CHAIN VALLEY COLLIERY – MODIFICATION 1

Response to Submissions

Section 96 Modification to SSD-5465

Prepared for LakeCoal Pty Limited
September 2014

FIGURE 4. Predicted Subsidence Isopachs Due to the Formation of the Connection Headings in the Fassifern Seam and Surface Features (Reproduced Figure 18b from DGS 2014)

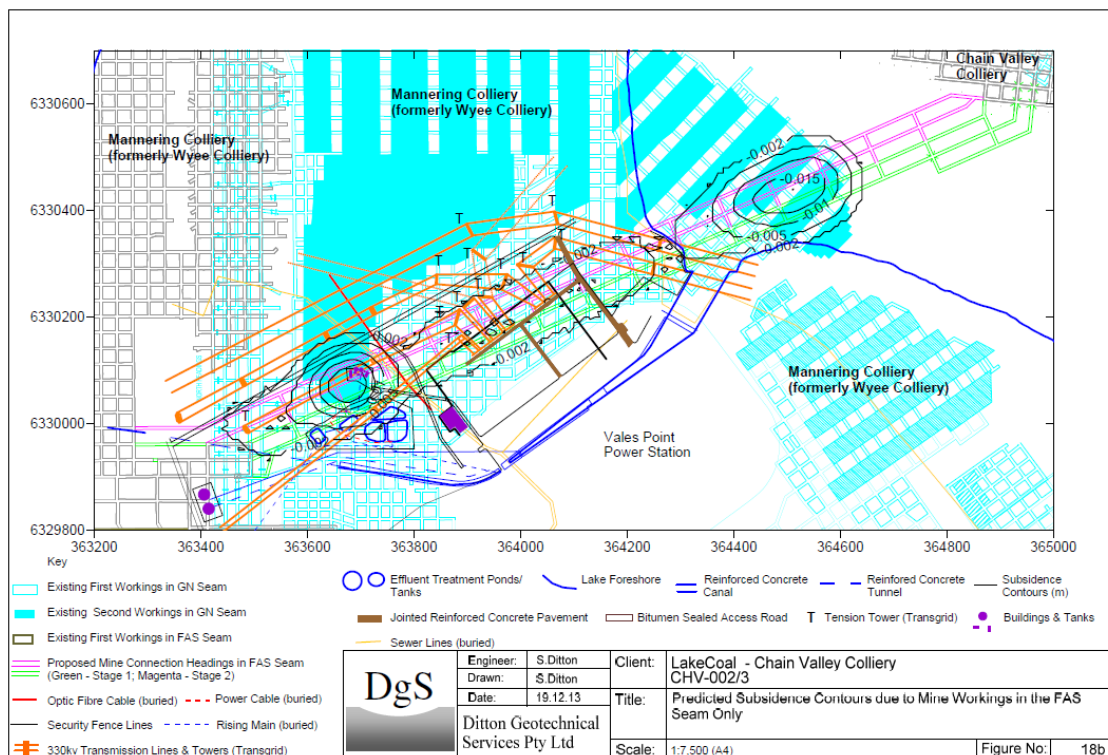
Figure 4 shows isopachs of the increase in surface subsidence as a direct result of forming the proposed connection headings along with the various surface features that are of relevance. This figure along with those detailing tilts, curvatures and strain provide a credible basis for assessing the likely impact on the various defined surface features due to the formation of the Fassifern Seam connection headings.

The TransGrid infrastructure of the Vales Point sub-station and nearby transmission towers (some of which are known to be tension towers) is situated above first workings in the Great Northern Seam such that the predicted increase in vertical subsidence as a result of forming up the proposed connection headings in the Fassifern Seam is 6 mm and less, again noting the conservative assumptions used by DGS when calculating these values. The associated maximum values of curvature, tilt and strain are $< 0.03 \text{ km}^{-1}$, $< 0.2 \text{ mm/m}$ and $< 0.3 \text{ mm/m}$ respectively. **Figure 4** also indicates that the majority of the TransGrid tension towers are located outside the 2 mm additional surface lowering isopachs so will be influenced by $< 2 \text{ mm}$ of vertical lowering due to the proposed mining.

FIGURE 4. Predicted Subsidence Isopachs Due to the Formation of the Connection Headings in the Fassifern Seam and Surface Features (Reproduced Figure 18b from DGS 2014)

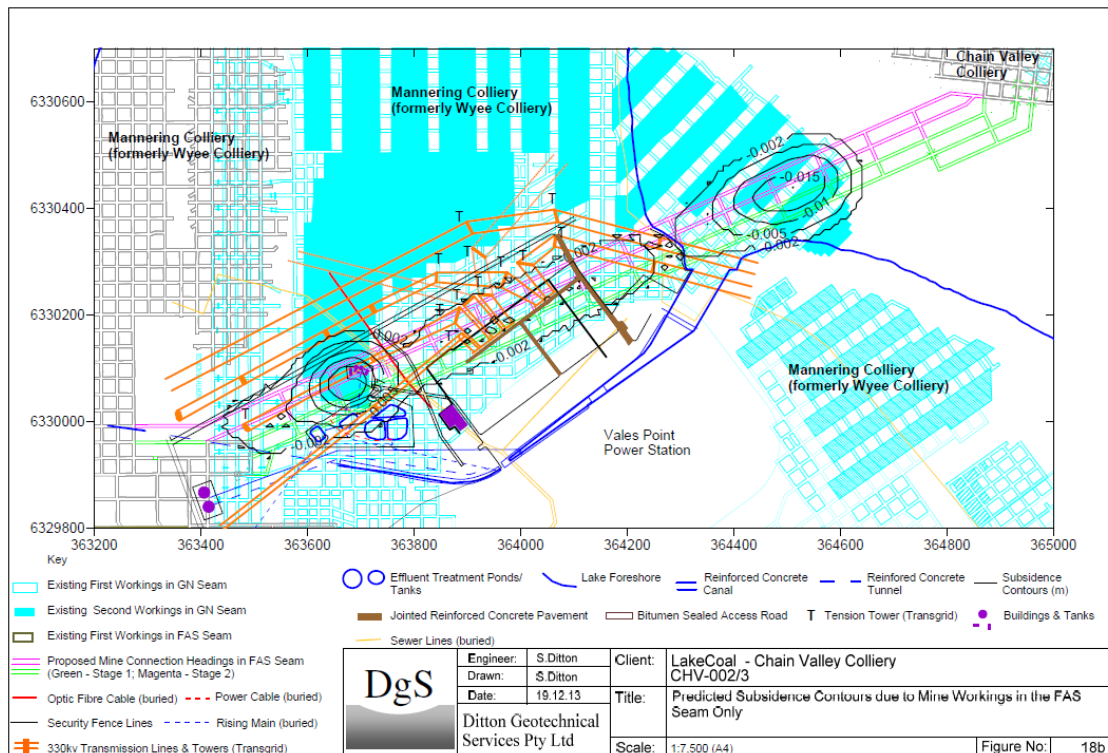
Figure 4 shows isopachs of the increase in surface subsidence as a direct result of forming the proposed connection headings along with the various surface features that are of relevance. This figure along with those detailing tilts, curvatures and strain provide a credible basis for assessing the likely impact on the various defined surface features due to the formation of the Fassifern Seam connection headings.

The TransGrid infrastructure of the Vales Point sub-station and nearby transmission towers (some of which are known to be tension towers) is situated above first workings in the Great Northern Seam such that the predicted increase in vertical subsidence as a result of forming up the proposed connection headings in the Fassifern Seam is 6 mm and less, again noting the conservative assumptions used by DGS when calculating these values. The associated maximum values of curvature, tilt and strain are $< 0.03 \text{ km}^{-1}$, $< 0.2 \text{ mm/m}$ and $< 0.3 \text{ mm/m}$ respectively. **Figure 4** also indicates that the majority of the TransGrid tension towers are located outside the 2 mm additional surface lowering isopachs so will be influenced by $< 2 \text{ mm}$ of vertical lowering due to the proposed mining.

Figure 4. Water level changes in a coastal lagoon with an entrance open to coastal waters.

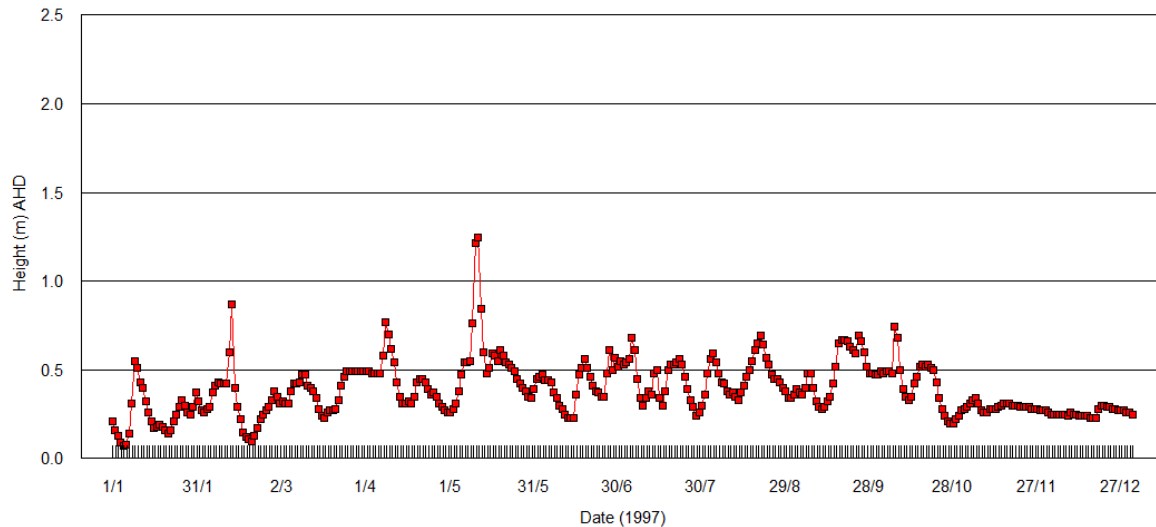
This statement suggests that Lake Macquarie is a static system and that 20mm of subsidence will allow saltwater from the lake to penetrate further inland to affect sensitive vegetation. As shown in Figure 4, extreme events can raise the water level of Lake Macquarie to around 1.3m above AHD allowing saltwater to penetrate far inland in low lying areas of the foreshore. On a monthly basis, changing atmospheric pressure means that the water level of Lake Macquarie can cycle between 0 and 0.7m above AHD. On lee shores wind wave set up can raise the water level of the lake to even higher levels for short periods. Furthermore, high wind waves can deposit a thick band of vegetable detritus and sand that acts as a dam along the shoreline that prevents accumulated saltwater from draining out of wetlands for several days. It is also noted that humans have occupied much of the shoreline of Lake Macquarie. Native vegetation has been stripped from the lake perimeter, seawalls built and in many places lawn mowers can operate to the water's edge. The land controlled by CVC and Vales Point Power Station, and the subject of this application, still contains several hundred metres of low lying natural vegetation in good condition. A subsidence of 20mm or 'zero subsidence, is highly unlikely to have any measurable effect on this remaining vegetation as the elevation of the land rises behind the shoreline.

Figure 5A. Mean percentage changes in PAR with depth at Station 1 - Wyee Point over 12 months. **Figure 5B.** Actual percentage changes in PAR at Station 1 - Wyee Point on the morning of 21-4-83.

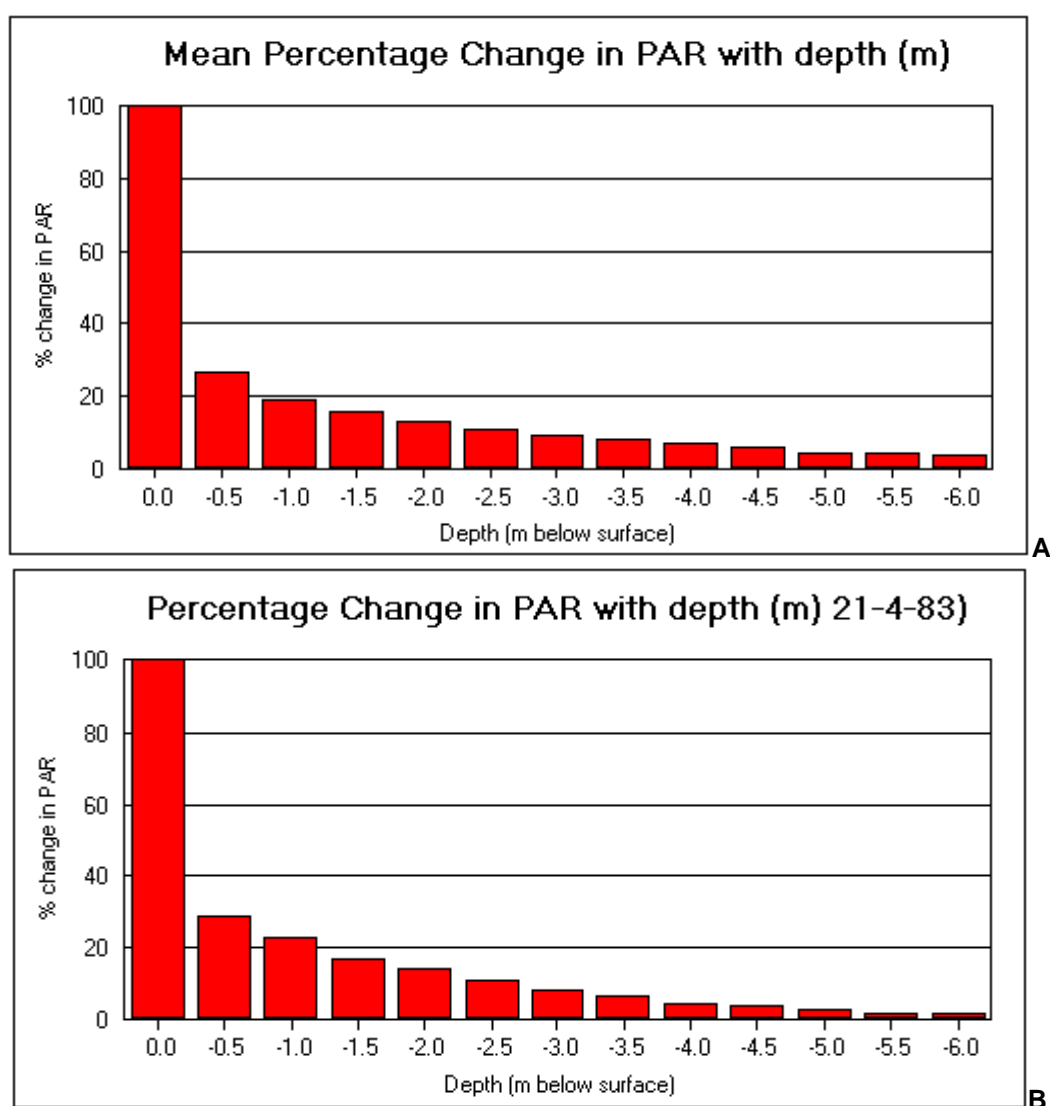
The seagrass beds in the area monitored for CVC ranged in depth of 0.5 to 2.12m below AHD. Only 14% of the surface light reaches the sea bed at 2.0m below AHD (Figure 5). Extending to slightly deeper depths are patches of filamentous algae. Seagrass beds in Chain Valley Bay and off Summerland Point may extend between 16.3 and 152.7m off shore as a continuous meadow (Laxton and Laxton 2014). At the offshore edge of the seagrass beds, the lake bed drops quickly to 6m below AHD. This is the location of the mud basin which occupies most of Lake Macquarie. At this depth only between 2 and 4% of the surface light penetrates to the lake bed. The surface of the mud basin was very fine silt, but buried in mud were vast quantities of intact bivalve and gastropod shells (Laxton and Laxton 2014a).
